# APPROVED MINUTES

## January 18, 2024, Standards Committee Meeting

RE: Minutes from the January 18, 2024, Standards Committee Meeting

E 801-TPAR-10 PEDESTRIAN DIVERSION, RIGHT-OF-WAY SIDE (proposed new)

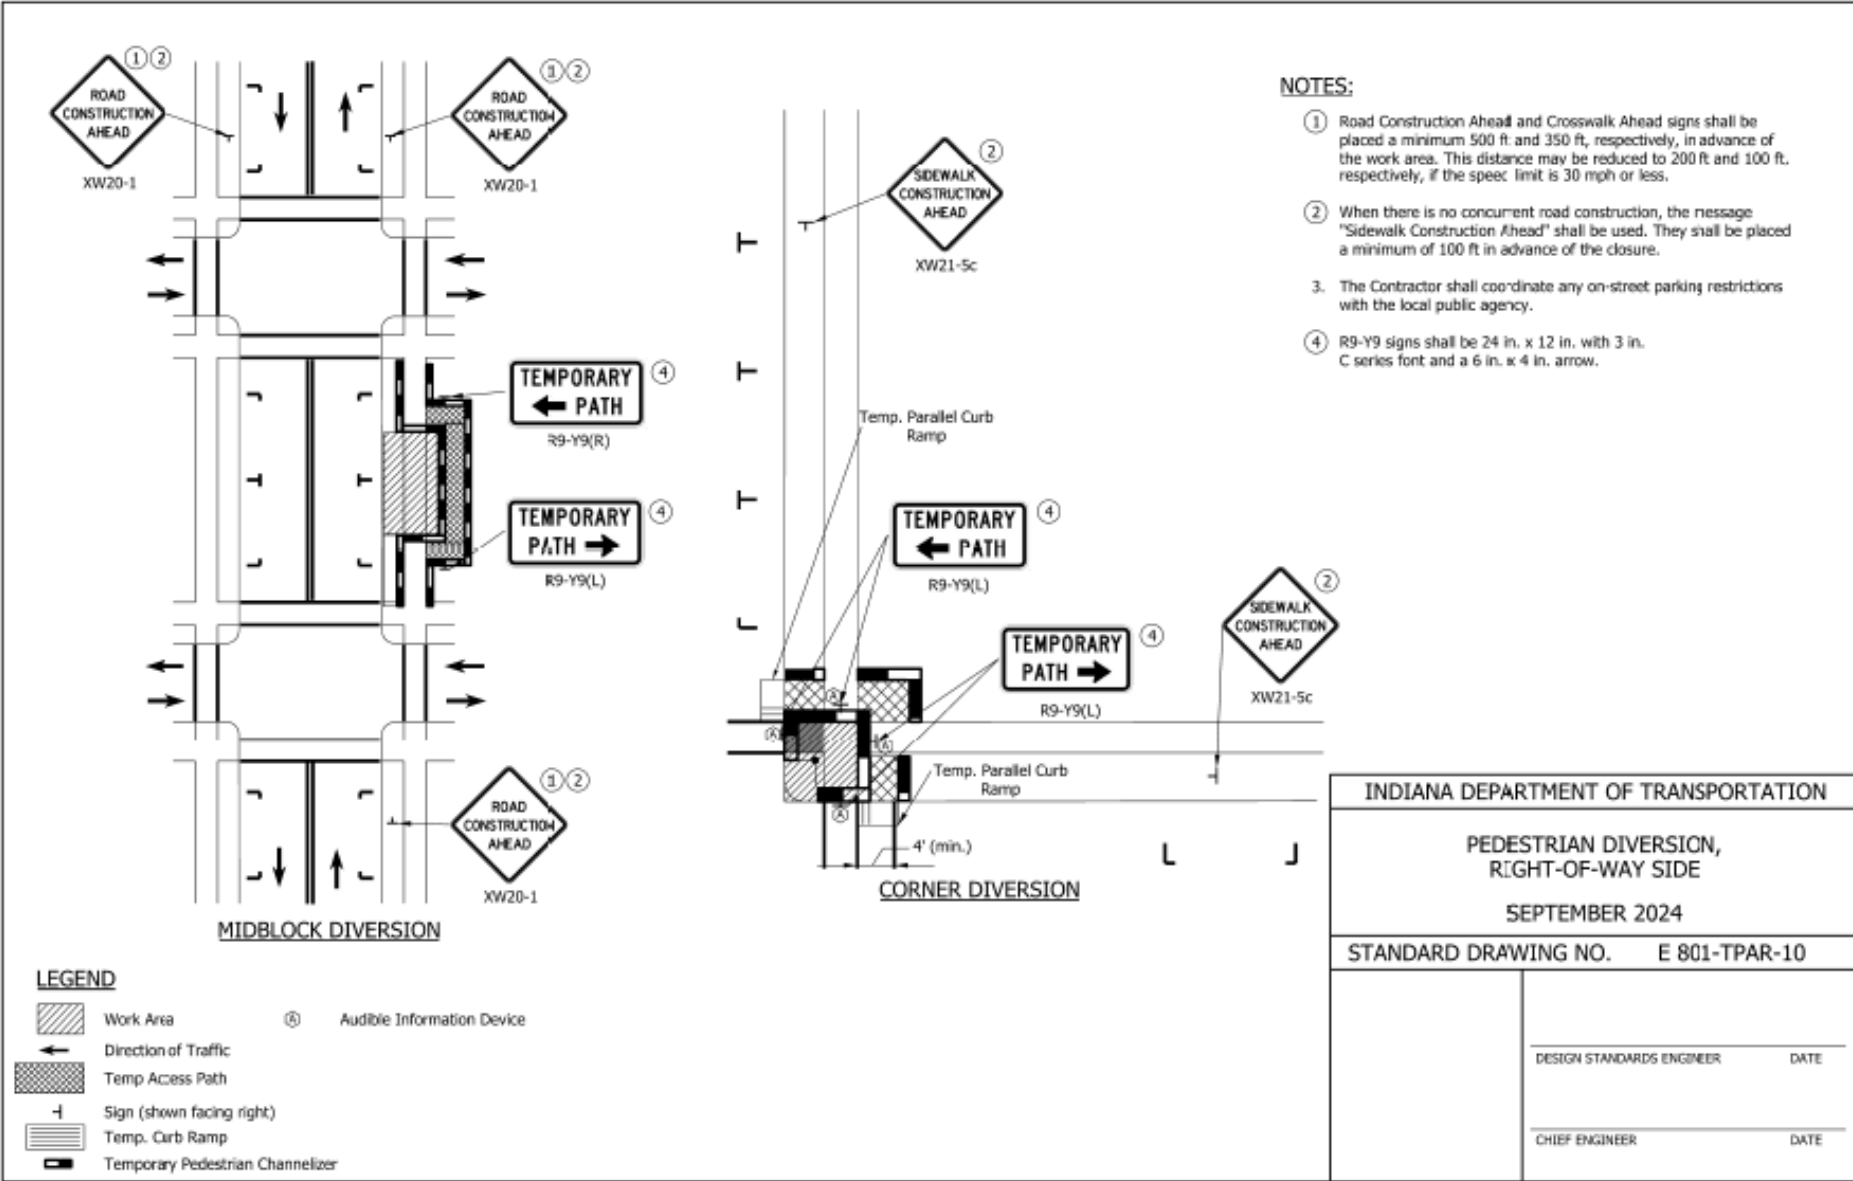
Mr. Koch stated, concerning the 801-TPAR drawings-02, -04, -05, -06, -07, -08, -10: everyone has RCA's. In order to minimize costs, burdens, and liability if the note is overlooked, and the associated costs to change out signage as the work progresses and to maintain a stock of the signs; please consider striking note #2. Also, for drawings 801-TPAR-03, -05, -07, understand we are attempting to capture both approaching sidewalks yet we are adding a considerable amount of sign clutter. Are two RCA's needed as a single is utilized elsewhere? And for 801-TPAR-10, the corner diversion requires 'sidewalk construction ahead' yet includes note #2. Similar to elsewhere, should RCA's be required 1<sup>st</sup>, ideally only RCA's for simplification. Mr. Boruff responded that we could make it an option, which would eliminate the liability and added costs concerns. The Contractor can use RCA's if they have them in stock or would otherwise prefer the alternate, more precise message. Mr. Koch said that sounds reasonable. The drawings have been revised as shown, following discussions by Mr. Duncan from FHWA, Mr. Koch, Ms. Smutzer, Mr. Davis, and Mr. Boruff.

REVISION TO SPECIAL PROVISIONS AND STANDARD DRAWINGS  
 E 801-TPAR-11 TEMPORARY CURB RAMPS (proposed new)

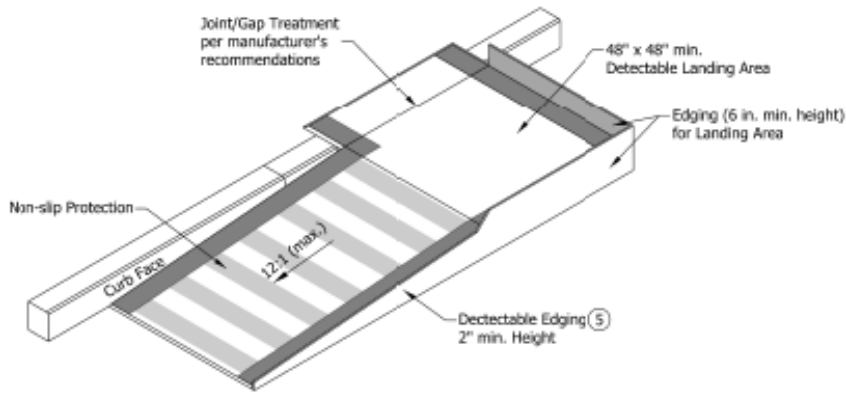
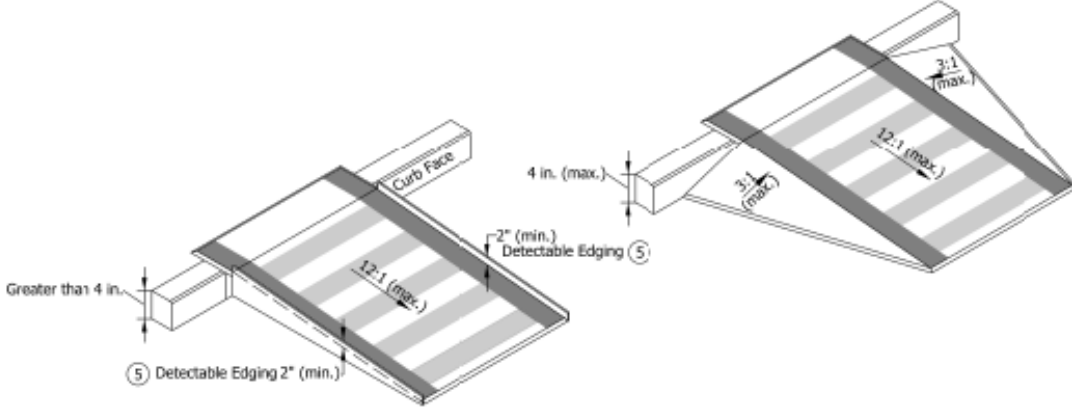
6. The rise of a single temporary curb ramp shall be no more than 30 in. If more than one temporary curb ramp is needed at a location due to the change in elevation, a minimum 5 ft landing area shall be used between curb ramps. The landing area shall have a slope of less than 2.00%.

E 619-PRWS-03 COATING REQUIREMENTS FOR EXISTING STRUCTURAL STEEL ENCASED IN CONCRETE (proposed draft, revised)

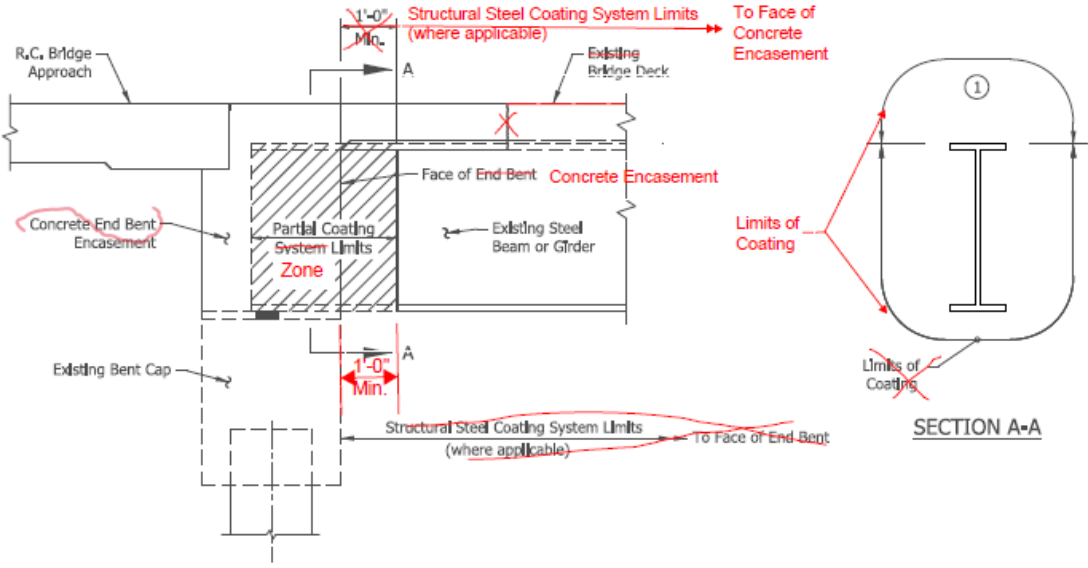
Ms. Mouser showed revised drawings and explained the revisions (E 619-PRWS-03).  
 Mr. White proposed the acceptance of the drawings revised as shown.
